ADDENDUM NO. 5

Date of Addendum: 5/19/2021

PROJECT NAME: TC Jester Park Playground
PROJECT NO: F-COC003-0001-4

L0.02

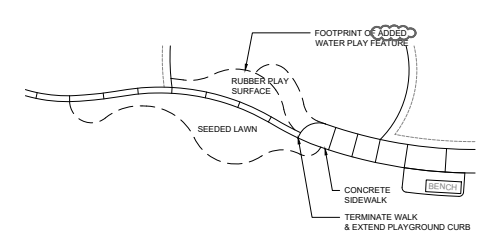
3. Delete Sheet L0.02, Bid Alternate Sheet, and replace with Sheet L0.02 Addendum 5.

All deducts changed to add. Bid Alternates are not included in the base bid.

All improvements included in the base bid. Each Bid Alternate is deduct to the contract as follows:

- **Bid Alternate #1** (C03) concrete sidewalk and decomposed granite connection in street R.O.W.
- **Bid Alternate #2** (C03) Water Play Feature, including the following improvements related to the Water Play Feature: water supply, handspan, drain and connector pipe, concrete subslab and exposed aggregate topping, boulders, additional concrete walk and flush curb. Refer to 02L0.02 for base bid requirements.

- **Bid Alternate #3** (C03) sandblasted leaf pattern at entry plaza concrete surface. Base bid requirements: broom finish concrete with tooled joints only, no sandblasting.

- **Bid Alternate #4** (C03) landscape boulders (outside of water feature). Base bid requirements - complete curbs/wood fiber as needed.
- **Bid Alternate #5** (C03) trees and related irrigation as indicated on the Planting Plan.

- **Bid Alternate #6** (C03) rubber play surface and concrete subslab. Base bid requirements: 1" of engineered wood fiber mulch within footprint of rubber play surface.
